To: Karl Schwing
District Director, San Diego Coast
California Coastal Commission

Re: Item Th11a, Application No. 6-21-0566, 1601 South Pacific Street, Oceanside, San Diego County

The red line traces concrete grouting

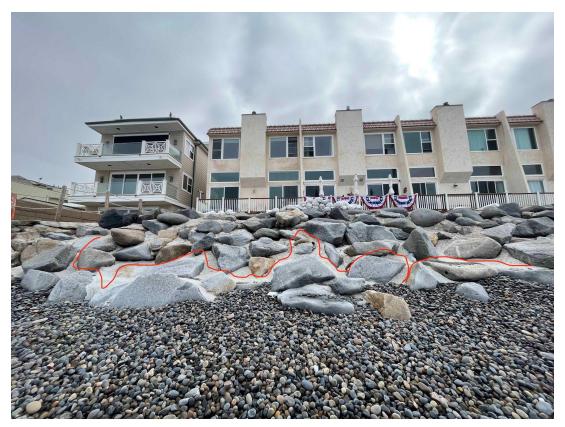
We appreciate the additional special conditions re: the unpermitted stairways and concrete at this property, including the Construction Documentation Plan which requires photo and/or video evidence that the stairways and concrete grouting are properly removed (Special Condition 2). Similarly, the Long-Term Monitoring Program requires the applicant to remove any additional concrete grouting that becomes exposed or dislodged in the future (Special Condition 3f). This is important because a sizable portion of the revetment is currently buried under sand and cobbles, making it impossible to corroborate the applicant's claim that concrete grouting is only present on the upper portion of the revetment. For example, the following photo from July 6, 2023, shows the presence of concrete grouting at the lowest visible areas of the revetment:
